SYNCHRONOUS BELT DRIVE SYSTEM TECHNICAL SERVICE BULLETIN

AUDI AND VOLKSWAGEN 1.8L SERVICE INFORMATION

BULLETIN PA005-12

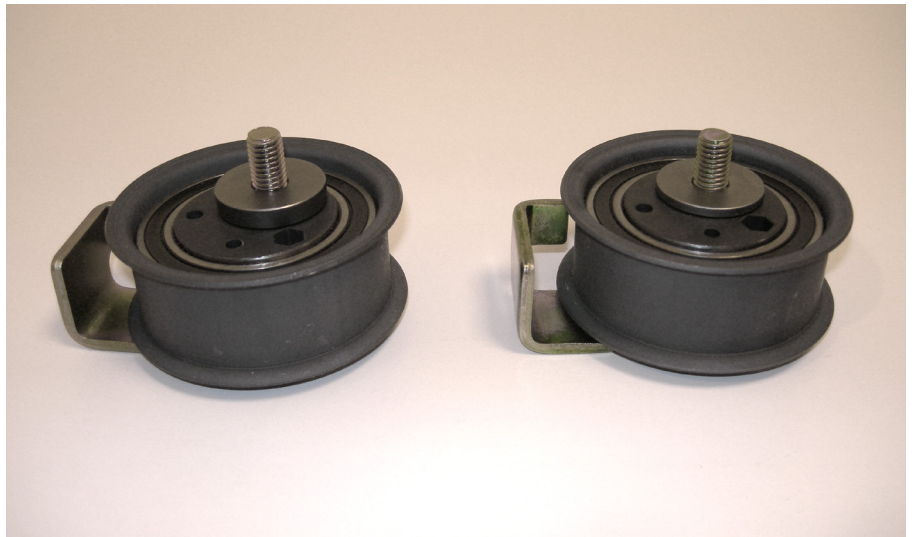
Please note if you are removing a system that has been updated, there could be a difference in the spacer that is included with the pulley. The one that is included in the 2523170 kit has a 6mm thick spacer; the other which is only available from the OE is 3mm thick. These are not interchangeable on the drive. Incorrect distance will cause premature belt and drive system failure.

Always double check the component you are removing. You may encounter a difference in spacer thickness of the tensioner pulley. If the spacer currently on the vehicle is 3mm, then it will need to be obtained from the OE. If the spacer is 6mm it will be supplied in the NAPA Belts/Hoses 2523170 or WPK42299. This will guarantee proper system alignment.

OE - 058109243E
NAPA Belts/Hoses - T43065
(included in NAPA Belts/Hoses - 2523170 Kit)

Note the size of spacer is 6mm

OE 058109243D
NAPA Belts/Hoses - N/A

Note size of spacer 3 mm
